TECHNICAL BULLETIN

Document TB04-11-01

Product Label

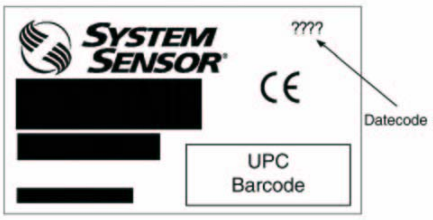
This issue may affect units manufactured between July 6th, 2004 (date code 4071) and September 29th, 2004 (date code 4095).

The date code can be found on the unit's product ID label or on the carton label. If you have any new, unused inventory within this date range, please contact your NOTIFIER Customer Service Representative to arrange its return and receive credit. To replace an installed FAPT-851 exhibiting the conditions described in this Technical Bulletin, please contact your NOTIFIER Customer Service Representative to arrange for a warranty replacement. Please order new detectors per your normal ordering procedure. FAPT-851's that are removed should be returned via our standard RMA process to receive credit and a $5 labor reimbursement.
